**REGULAR MEETING OF THE PLANNING BOARD  
WEDNESDAY – JUNE 10, 2015  
7:30 PM  
CITY COMMISSION ROOM  
151 MARTIN STREET, BIRMINGHAM**

**CITY OF BIRMINGHAM  
PLANNING BOARD ACTION ITEMS  
OF WEDNESDAY, MAY 13, 2015**

**CITY OF BIRMINGHAM  
PLANNING BOARD ACTION ITEMS  
OF WEDNESDAY, MAY 27, 2015**

ORIGINAL ISSUE DATE:  
MAY 11, 2015  
PEA JOB NO. 2015-053  
SCALE: 1" = 40'  
DRAWING NUMBER:  
**C-3.0**

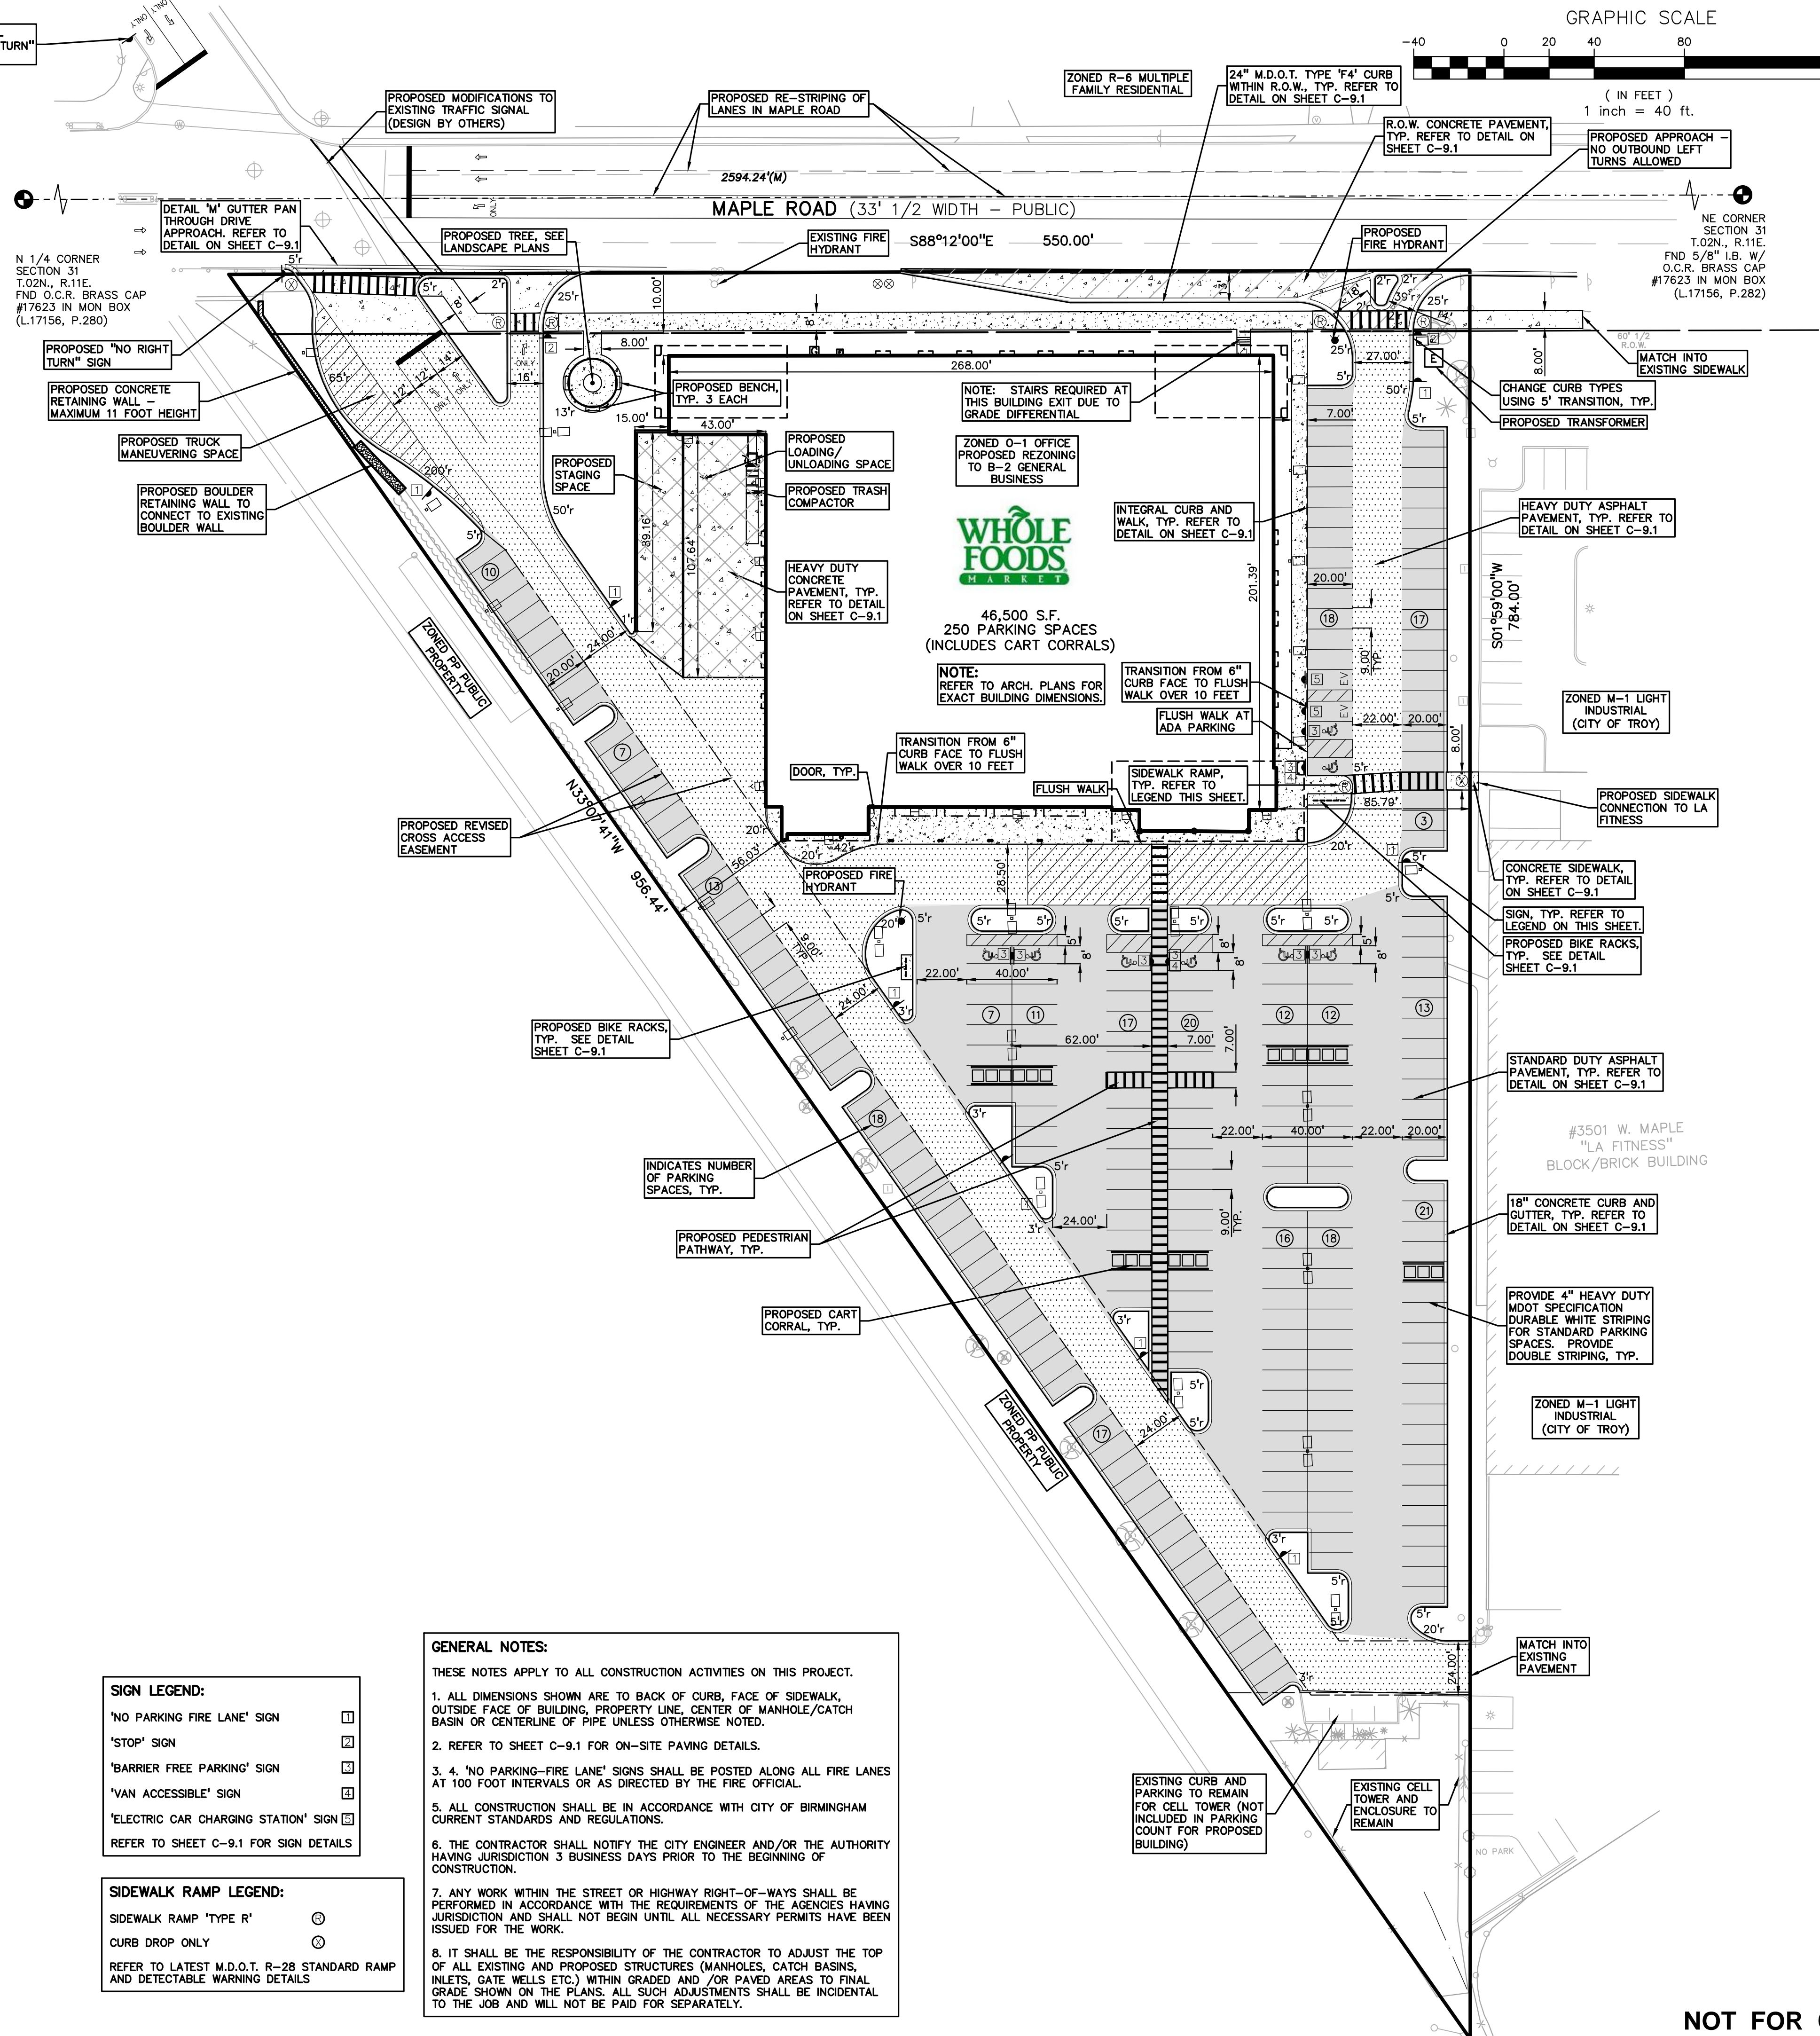
**However, fritted glass is not permitted. The applicant must remove the proposed fritted glass.**

**No material samples or colors have been provided at this time, but will be required at the time of Final Site Plan Review. The plans do not indicate the percentage of glazing provided; however it does not appear that the building as proposed meets the 70% glazing requirement as listed in section 4.83 of the Zoning Ordinance.**

- Ø A sidewalk that links the Maple Rd. side on the west to the store - so don't just treat that as a service entrance;
- Ø The grade change needs to be resolved;
- Ø Offices that have windows;

- (7) Add an active pedestrian entry along E. Maple Road; and
- (8) The applicant must provide material and color samples at Final Site Plan and Design Review.

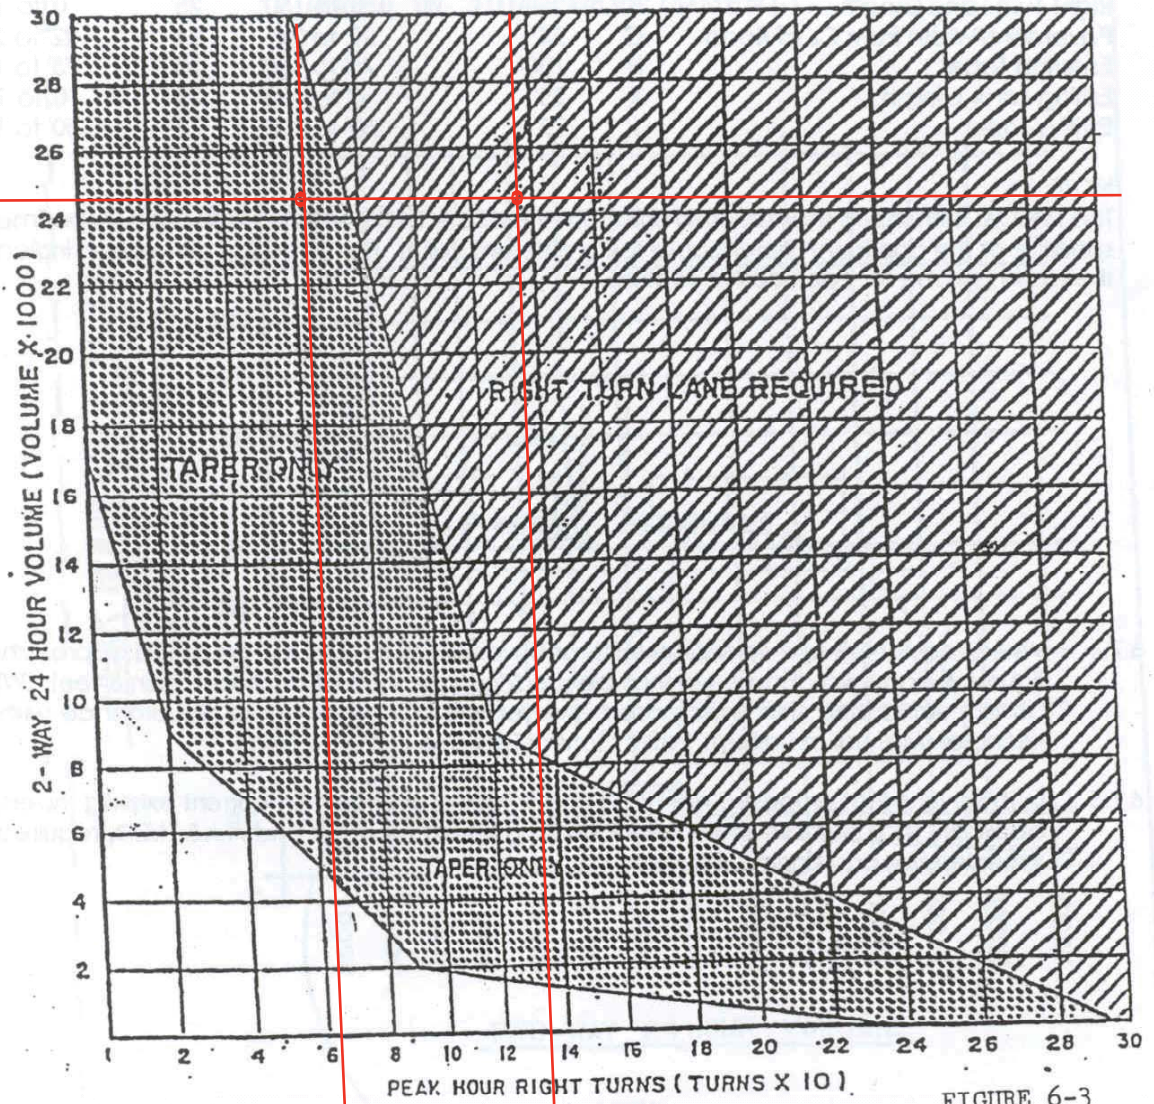
1. The proposed monument sign has been eliminated.
2. Attached please find a copy of the right turn lane warrant analysis for the proposed right turn proposed at the east entrance. Parsons based the analysis on the projected right turn volumes shown on Figure 6 of their traffic impact study and the 24 hour Maple Road volume cited on page 1 of the same study. The analysis shows a right turn lane is warranted.

SP10

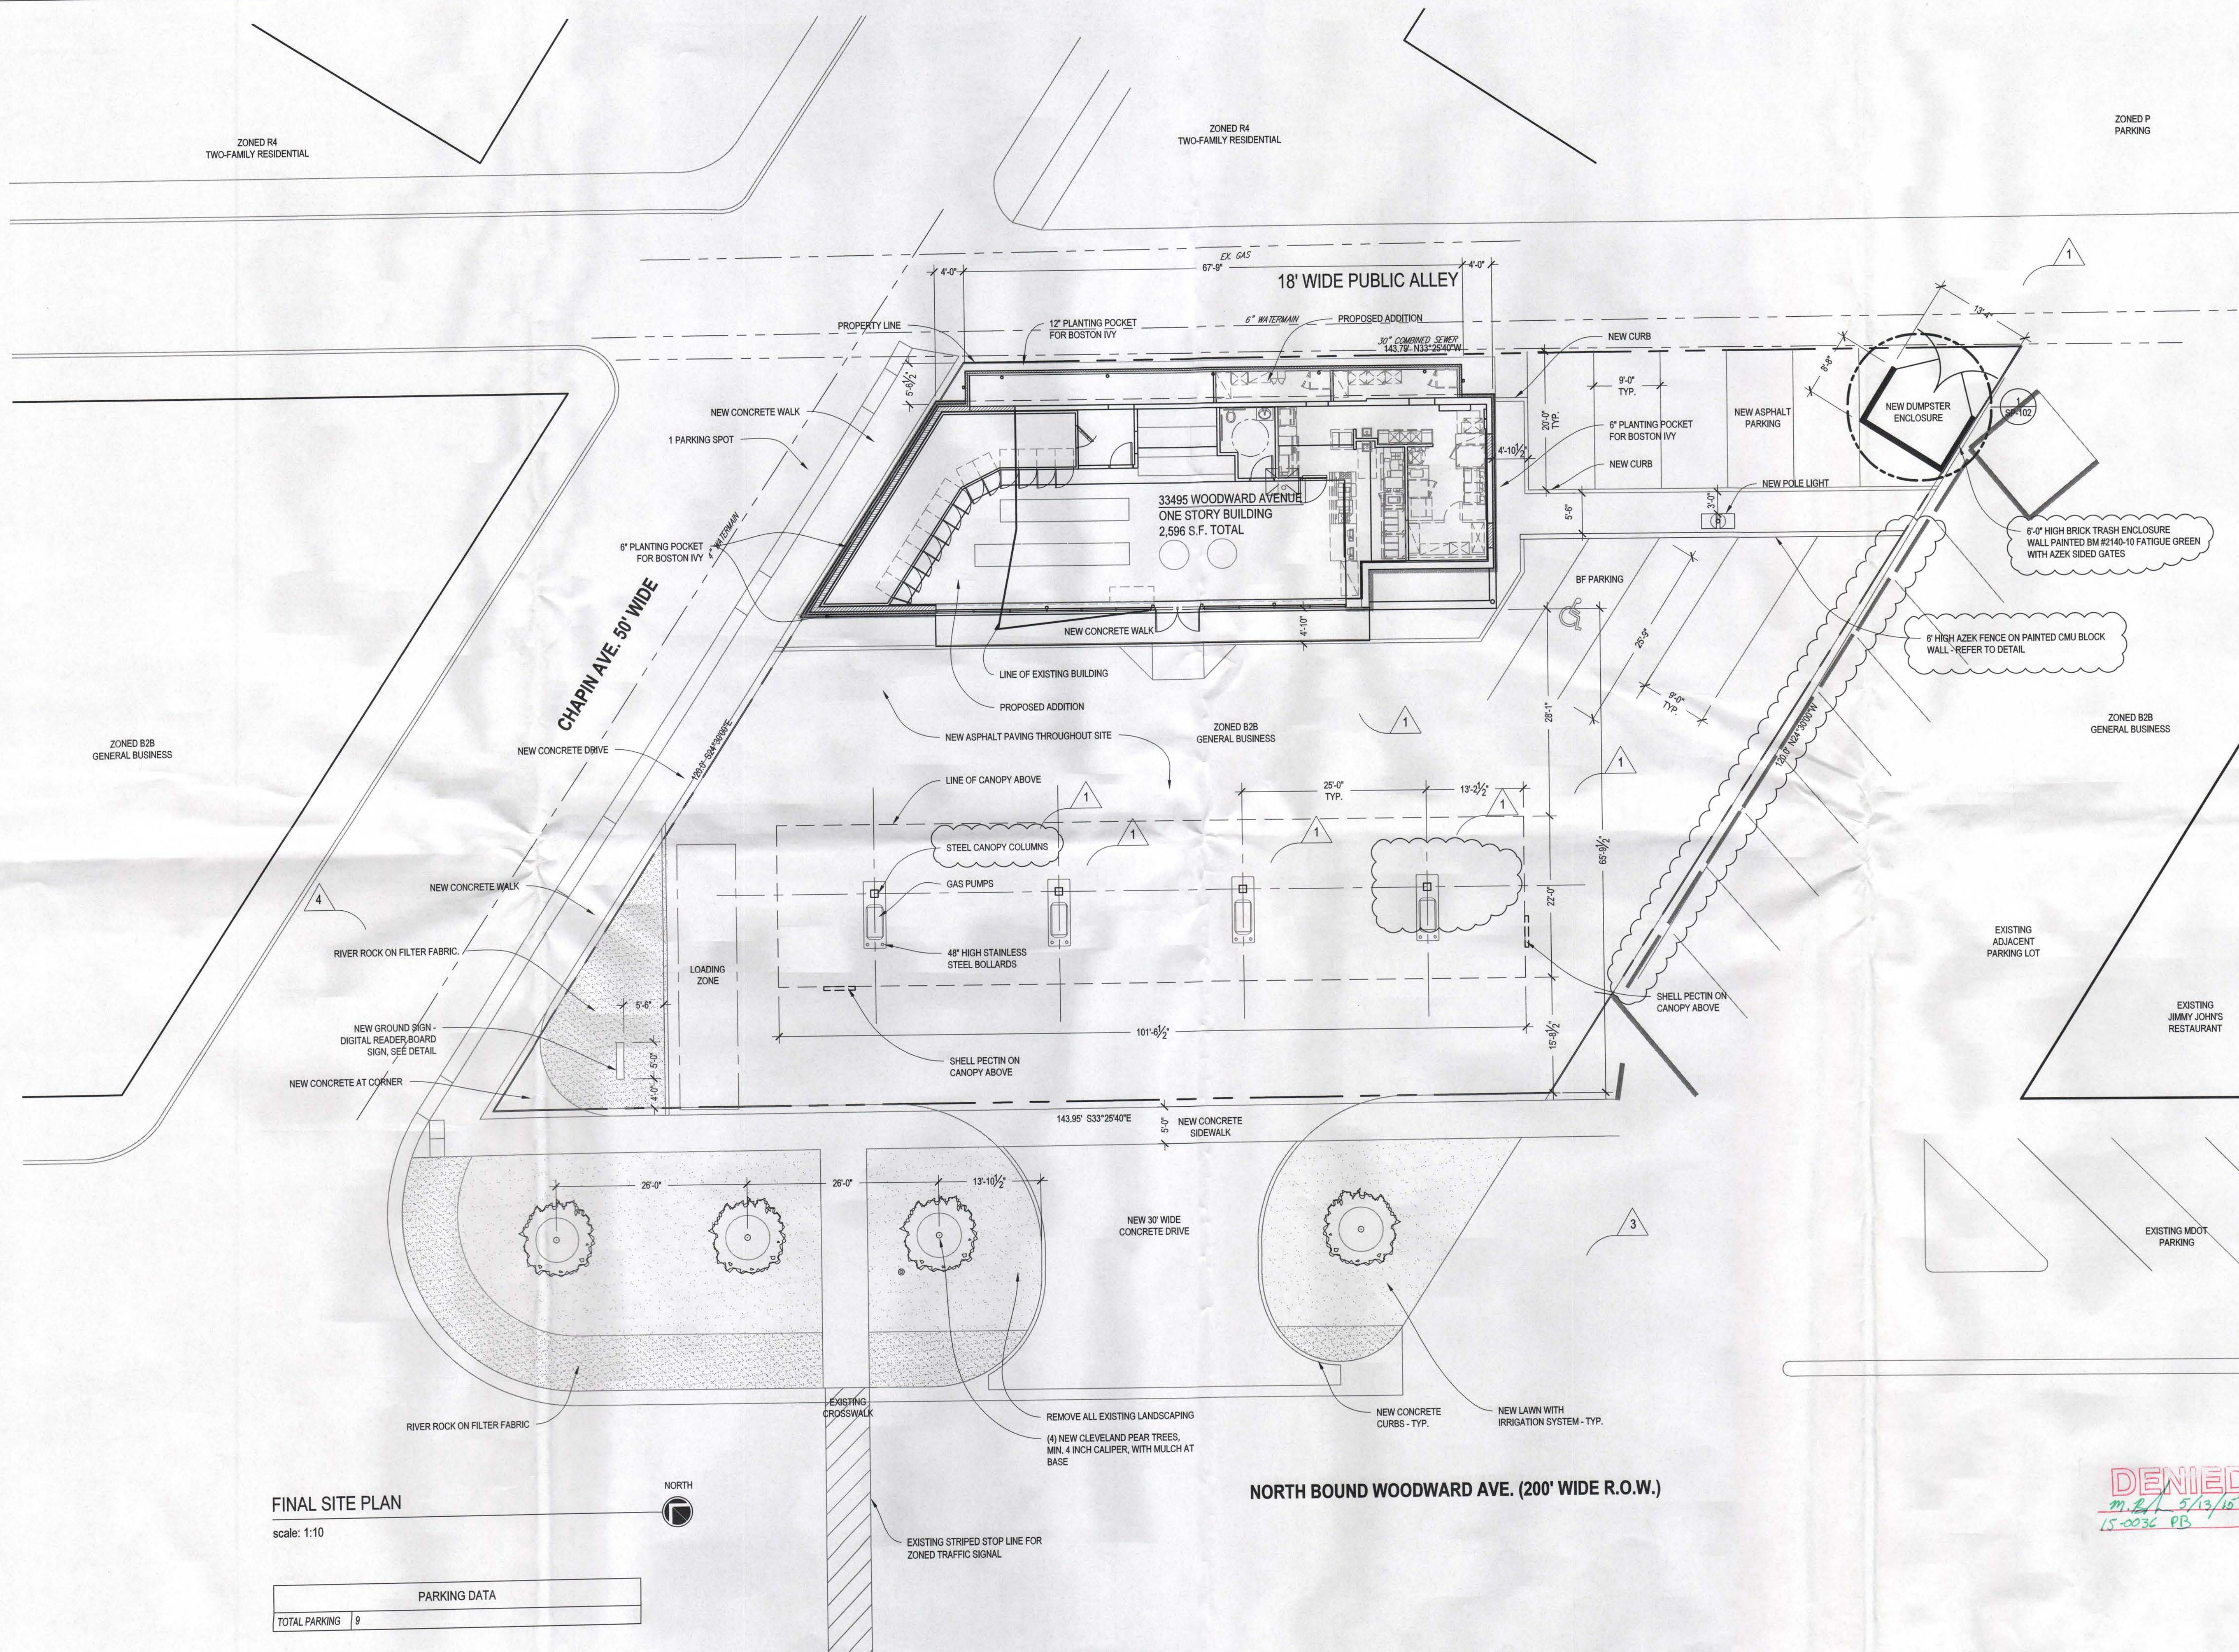
**DENIED**  
m.r. 5/13/15  
15-0036 PB
